UNIT	mm	C	PROJECTION		MODIFICATION		DATE
TOLERANCES UNLESS OTHERWISE INDICATED	1 = 0.4 10 = 10.2 100 = 10.1	MATERIAL			FINISH		
DRAWN	S. F. H.			DATE	16-6-74	TITLE	
TRACE				DATE		CIRCUIT DIAGRAM MKII	7470
MECH. APPR. <i>Alb</i>				DATE	31-7-74	MODEL	
ELEC. APPR. <i>J. P. H.</i>				DATE	31-7-74	BARLOW WADLEY XR 800 C	SCALE
BARLOW'S TELEVISION COMPANY							NEW GERMANY NATAL

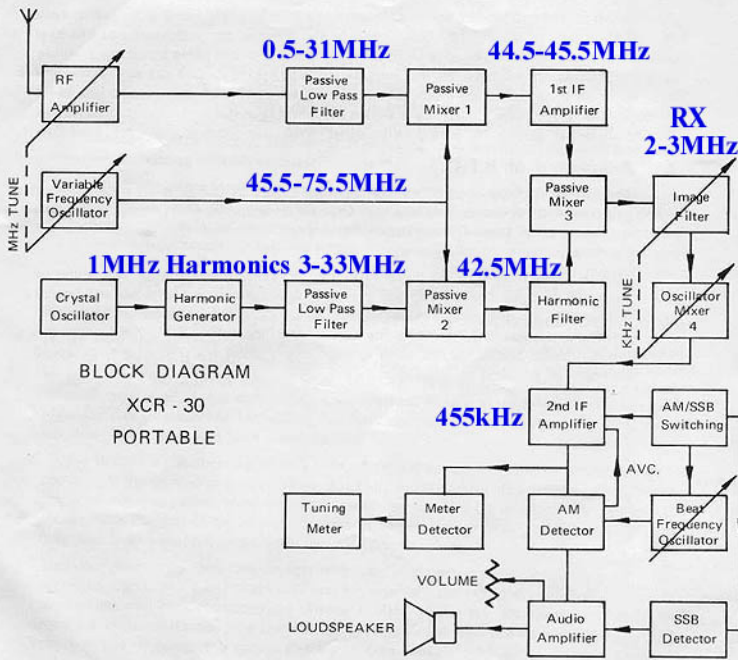
* MODIFICATIONS (FROM DECEMBER 1974)

7. C4 FROM $1\mu F$ TO $0.04\mu F$
8. R71 10Ω RESISTOR FROM JUNCTION OF L7/C43 TO POSITIVE CHASSIS
9. C39 FROM $470\mu F/10V$ TO $33\mu F/10V$
10. R72 $1K$ RESISTOR FROM TAP OF L2 TO POSITIVE CHASSIS
11. ADDITION OF C102 $33\mu F/10V$ CAPACITOR ACROSS THE METER
12. R62 $2K2\Omega$ NOW BECOMES $1K\Omega$
13. R63 100Ω NOW BECOMES A WIRE LINK
14. C45 $33\mu F/10V$ NOW BECOMES $1\mu F/10V$
15. C50 AND C62 NOW PLACED UNDER THE CIRCUIT BOARD AND NOT ON THE COMPONENT SIDE.
